RECORD COPY of ASI-018, included as  
3 of 6 ASIs for reference with SPA-03

PROJECT NAME:	One River Run (Kindred) 75 Hunki Dori Ct. Keystone, CO 80435	ASI #:	018	<input checked="" type="checkbox"/> OWNER <input checked="" type="checkbox"/> ARCHITECT <input type="checkbox"/> CONSULTANT <input checked="" type="checkbox"/> CONTRACTOR <input type="checkbox"/> FIELD
PROJECT #:	117033	DATE OF ISSUANCE:	04/15/2024	
OWNER:	One River Run Acquisition Keystone Investments, LLC 132 West Main Street, Suite D Aspen, CO 81611	ARCHITECT:	OZ Architecture, Inc.	
		TO CONTRACTOR:	PCL Construction Services, Inc	
		CONTRACT FOR:	GMP/Building Permit Resubmittal	
		CONTRACT DATED:	September 23, 2021

DESCRIPTION: This ASI provides updated Architectural drawings to remove the Plaza Lift (Keynote 14.01) in the vicinity of the monumental stair on the South side of Area D and to change access and control as required to provide an alternate Accessible Route between the Gondola Plaza on L0 and the Public Courtyard on L1 through the Hotel portion of the project. These changes are being made at the request and direction of the Owner. Architect has confirmed with the AHJ that removing the lift is allowable by Co

SHEET TITLE:  
GARAGE FLOOR PLAN - AREA D

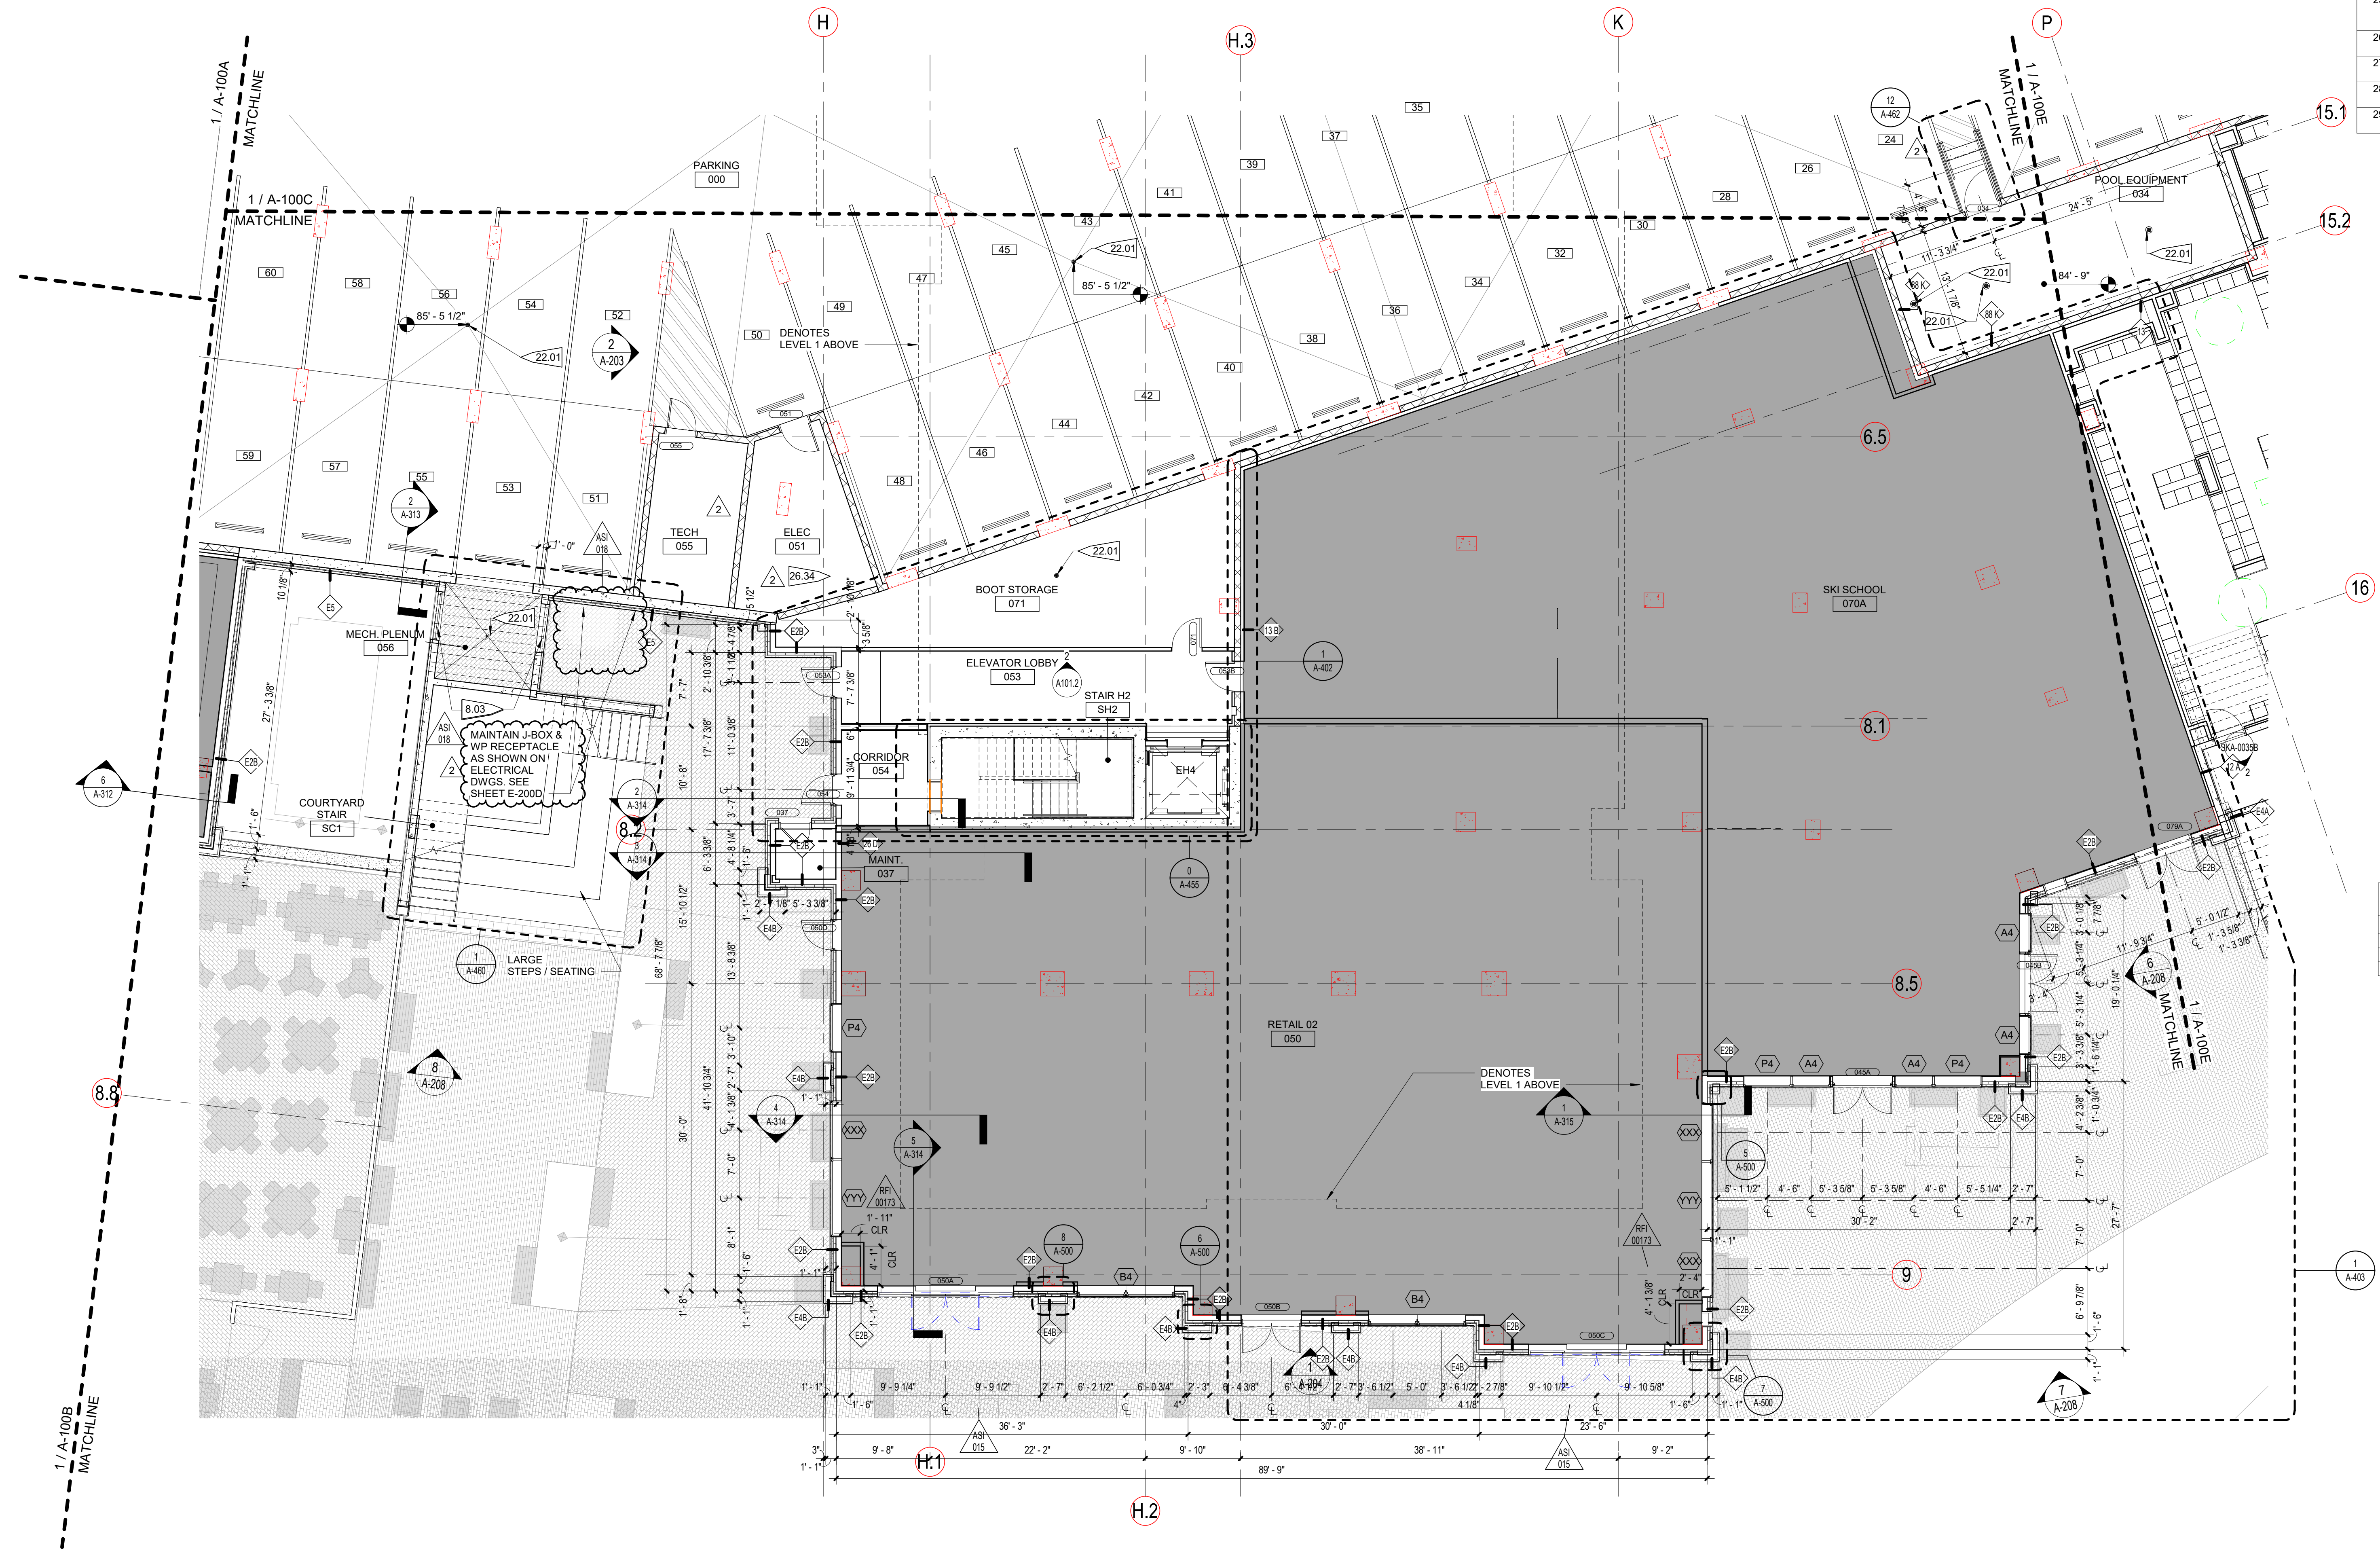
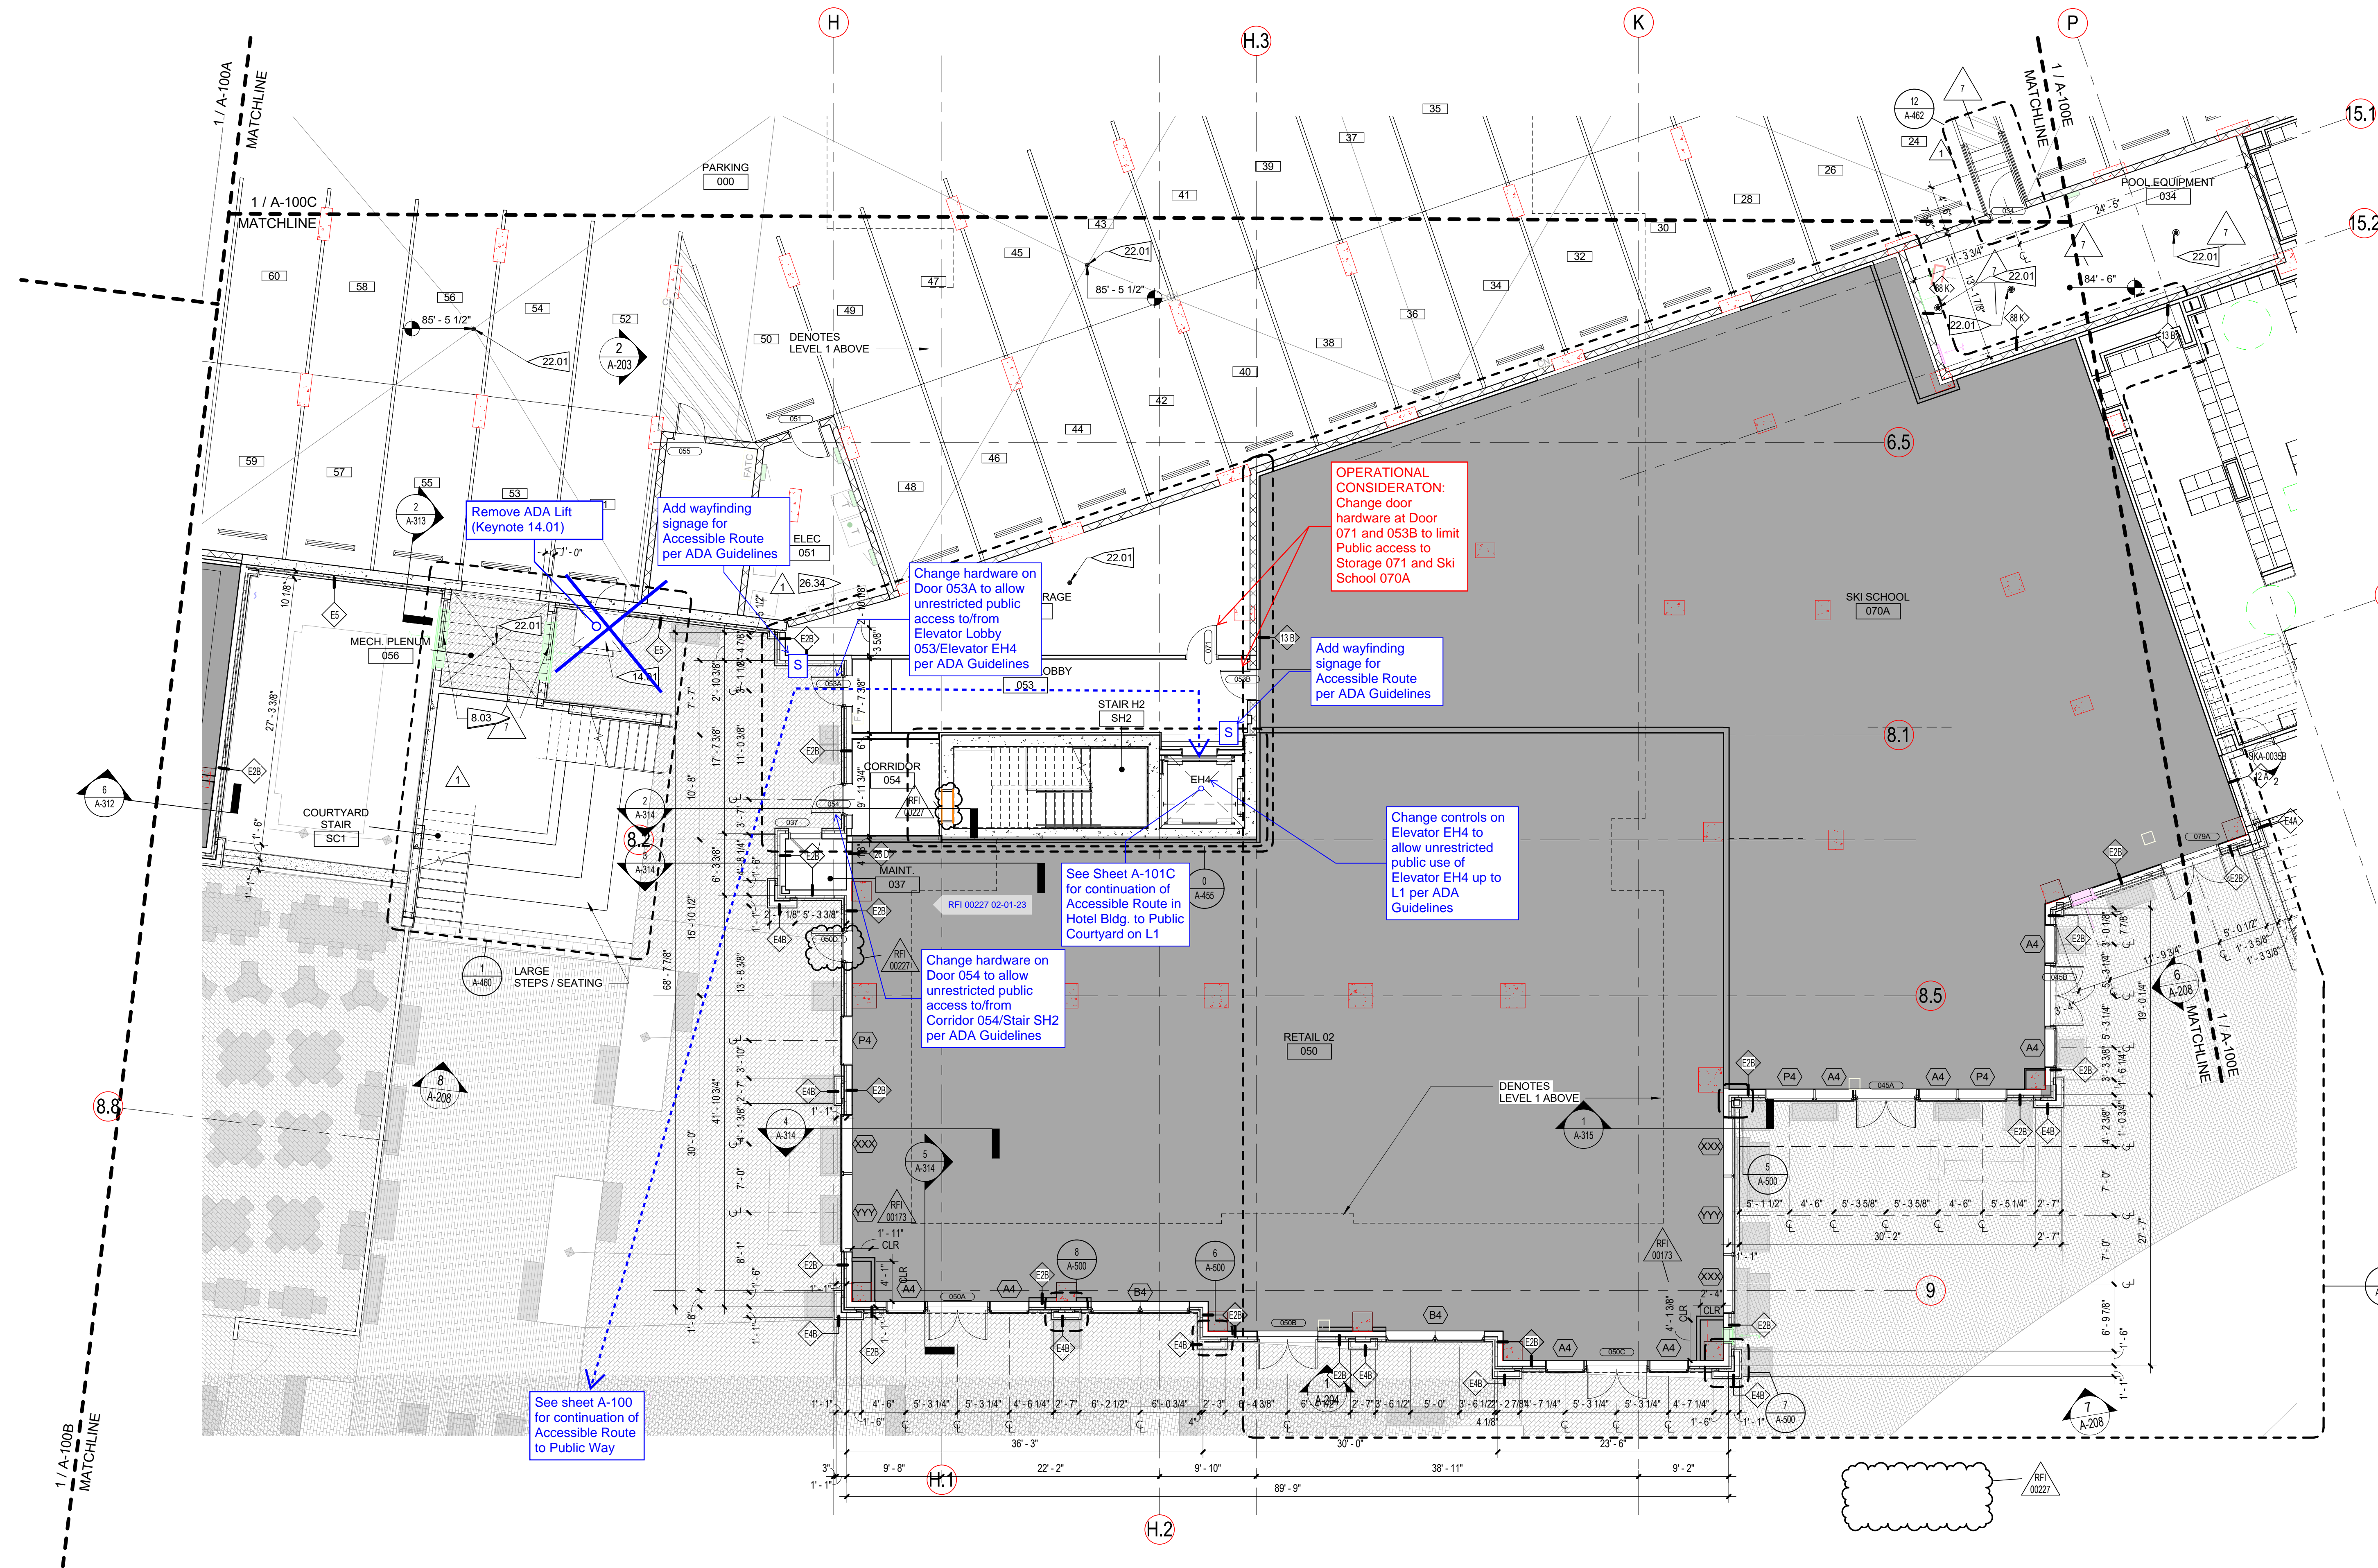
- 1.1 Remove ADA Lift (Keynote 14.01) and associated structural infrastructure. Maintain J-BOX & receptacle as shown on elec. drawing.
- 1.2 Change hardware on Door 053A & 054 so that this exterior door remains unlocked (no card reader) at all times.
- 1.3 Add Accessible Route signage on exterior wall adjacent to Door 053A.
- 1.4 Add Accessible Route signage on interior wall adjacent to Elevator EH4.
- 1.5 Change Elevator control at EH4 so that this elevator is available for public use from L0 to L1 (only) at all times; card reader may remain to control access to L2 and above.
